Owner :  
**KHALD SAYED HASHAIM ABDULLA ALHASIMI**

Drawing Title:  
**GROUND FLOOR PLAN**

Parcel ID **375-1748** Comm. **ALBARSHA THIRD**

DET. 1

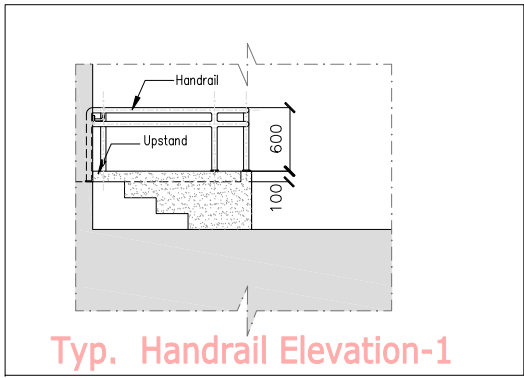
BATHROOM SIZE ENLARGED TO ACCOMMODATE HANDICAPPED ACCESSORIES THIS MODIFICATION SHOULD BE CHECKED STRUCTURALLY ON SITE TO ENSURE POSSIBILITY OF IMPLEMENTATION
